**REPORT OF THE INDEPENDENT HEARING
AND ASSESSMENT PANEL**

MOOLARBEN COAL PROJECT

Prepared for:

**Director General
Department of Planning
New South Wales**

Figure 5.1: Predicted versus measured vertical displacement over longwall panels at Ulan Colliery for L95%CL, Mean and U95%CL.

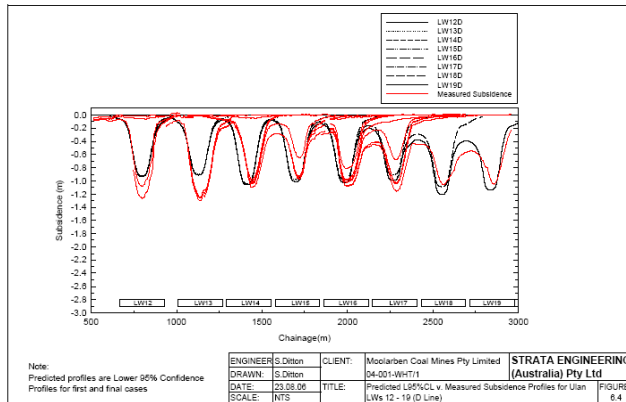
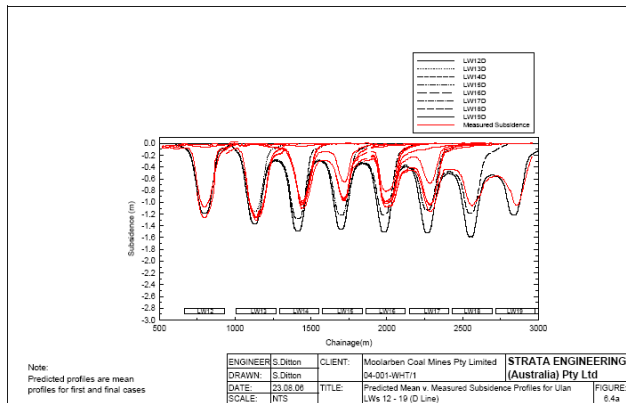
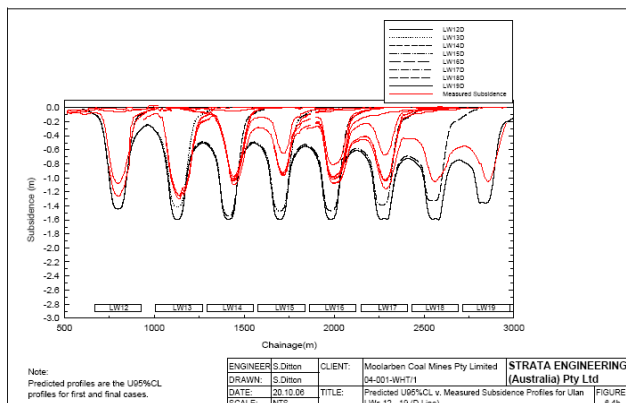
The IHAP has concluded that this uncertainty is adequately accounted for by SEPL basing subsidence predictions on the U95%CL. Furthermore, the IHAP recognises that the initial longwall panels in the MCP provide the opportunity to validate the prediction methodology and to calibrate it to MCP site specific conditions without unduly jeopardising the integrity of significant surface features.

When applied to Ulan Colliery data, the U95%CL approach has resulted in maximum vertical displacement having been over predicted by between 11 and 20% over one longwall panel, between 35 and 50% over two longwall panels and by between 50 and 70% over the remaining five panels, as illustrated on Figure 5.1(c). Predicted tilts have exceeded measured tilts over all panels. Predicted magnitudes of strain are not inconsistent with measured magnitudes but there is a lower level of correlation in regards to strain distribution (location).

It is not unusual in subsidence engineering for disparities to occur between predicted and measured uniform strain magnitudes and/or distributions. Irrespective of which subsidence prediction methodology is utilised, the prediction of uniformly distributed strain requires the use of some form of calibration factor. None cover all circumstances, either regionally or locally. The prediction of strain becomes more challenging once ground failure occurs, since strains may then no longer be uniformly distributed but rather may be concentrated at fixed locations. SEPL have utilised another calibration factor to convert uniform strains to concentrated strains. The

reasonableness and accuracy of this approach can only be confirmed in the light of local mining experience.

Figure 5.2: Base data used in SEPL fracture height model.

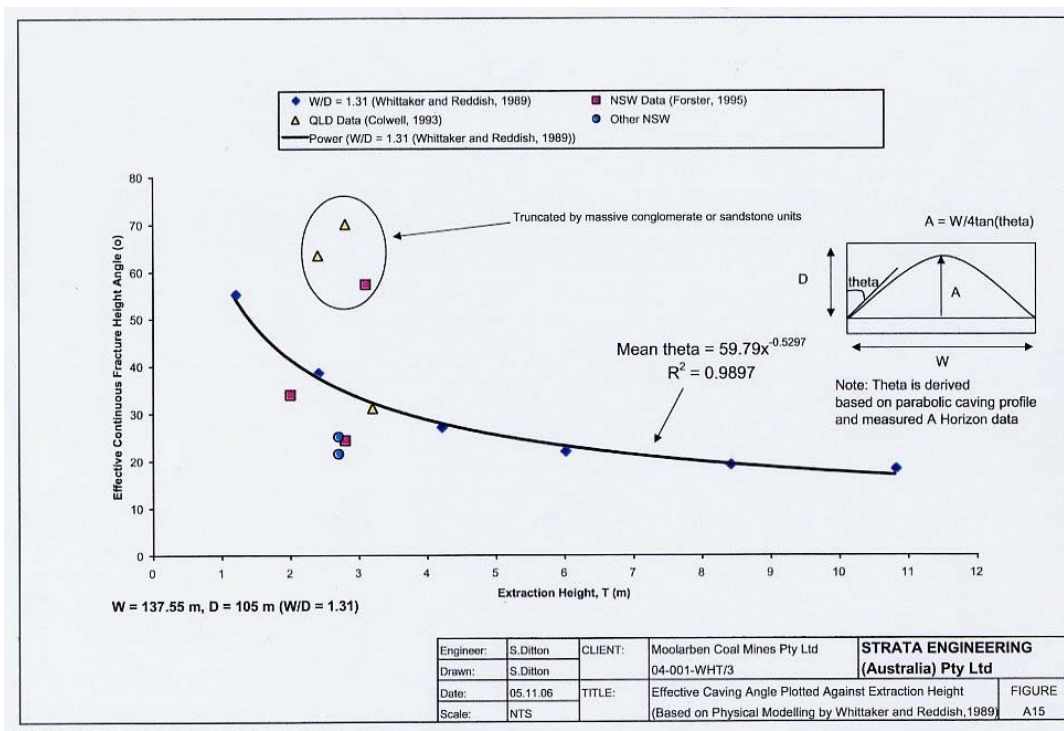
- Drilling fluid loss is not necessarily a reliable measure of fracturing and change in permeability.
- The revised model is premised on a number of untested, albeit reasonable, assumptions.

- The fracture heights predicted with the revised model are still less than those predicted by a number of other fracture models that have found successful application in the field and by some numerical models which also find successful application in the field. (Of course, these successful models might still be over-predicting the height of fracturing.)

The predicted fracture heights may well prove to be correct. However, the IHAP is of the opinion that the prediction model is not sufficiently robust for the IHAP to be confident in the outcomes at this point in time. The IHAP notes that SEPL have made various references to the model being preliminary, that the problem is of a complex

Figure 6.1: Piezometric surface for model MC1.4 layer 4 - Ulan seam at 2021 (after Aquaterra Figure 4.10 in PPR). Yellow shading shows approximate area of depressurisation within the coal seam induced by panel extractions.

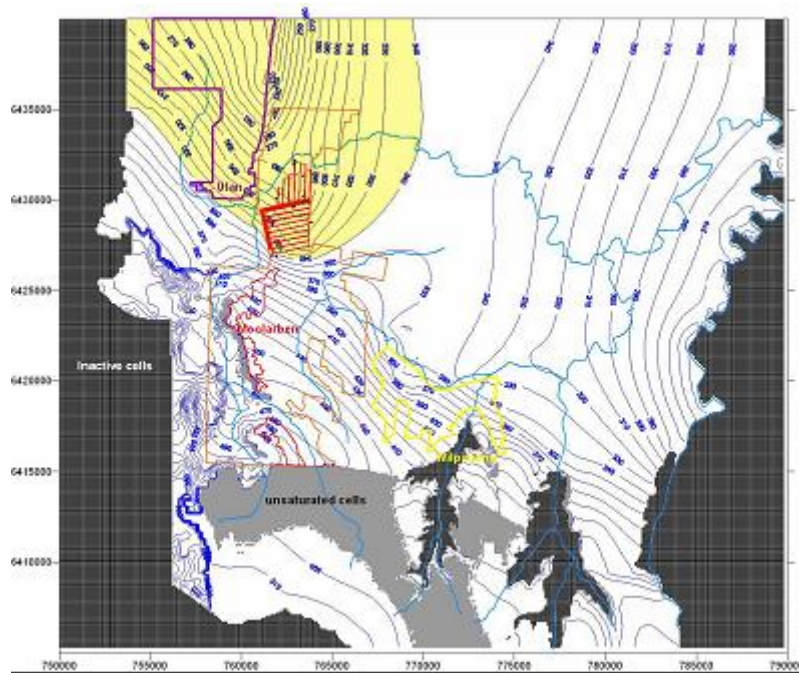
Model extents also appear to be insufficient to accommodate regional depressurisations arising from simulated mining, in a natural way. This is suggested by the geometry of the piezometric contours exhibited in Figure 6.1 in the north-western part of the model (shaded yellow). Here the distinct north-south trend of the contours suggests that pressure losses may be influenced and enhanced substantially by the northern and western boundaries of the model. The IHAP has difficulty in reconciling the impacts of mining with the impacts of boundary proximity.

Figure 6.2: Piezometric surface for model MC1.4 layer 3 – coal measures overlying Ulan seam at 2021 (after Aquaterra Figure 4.9 in PPR). The piezometric surface is generated for a horizon located approximately 25m above the seam. Expected depressurisation around extracted panels is not evident.

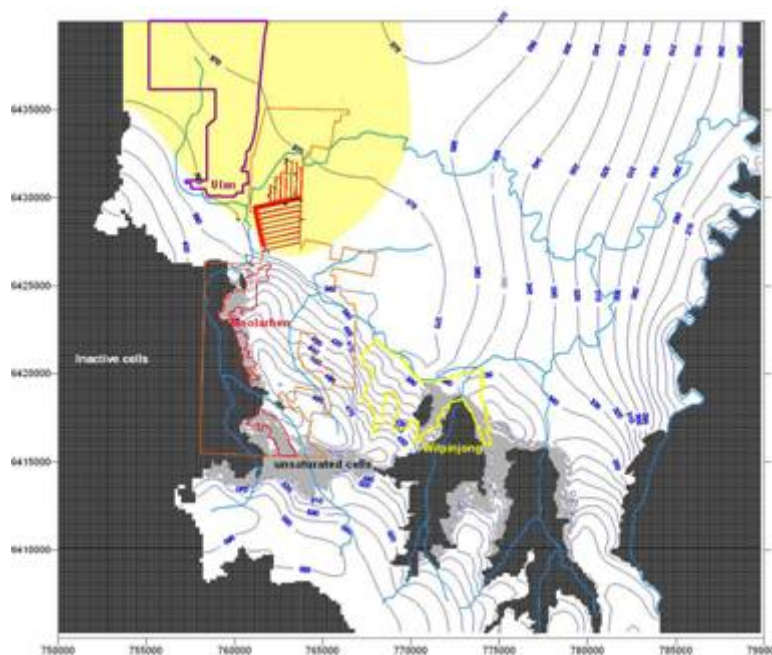
In view of the concerns raised by the IHAP in relation to prior modelling, a more detailed examination of the preferred model has been conducted. Such examination has identified ongoing concerns that include restrictive representation of the underground failure regimes at both UCML and MCMPL, leading to unrealistically low depressurisation of strata and associated under-estimation of seepage rates to mining operations. Figures 6.1 and 6.2 illustrate this. Figure 6.1²⁸ provides a model simulation of the groundwater head distribution or piezometric surface, within the Ulan seam (model layer 4) at the completion of proposed mining at MCMPL in 2021. Clearly there is a distinct piezometric low regime (shaded yellow) prevailing over both UCML and MCMPL extracted panels and surrounding areas. In contrast, Figure 6.2 provides groundwater heads within the overlying Permian strata at a datum horizon just 25m above the coal seam (model node horizon). These heads exhibit little evidence of seam depressurisation. The IHAP has difficulty in accepting this lack of pressure loss as a realistic prediction of the impacts of longwall mining.
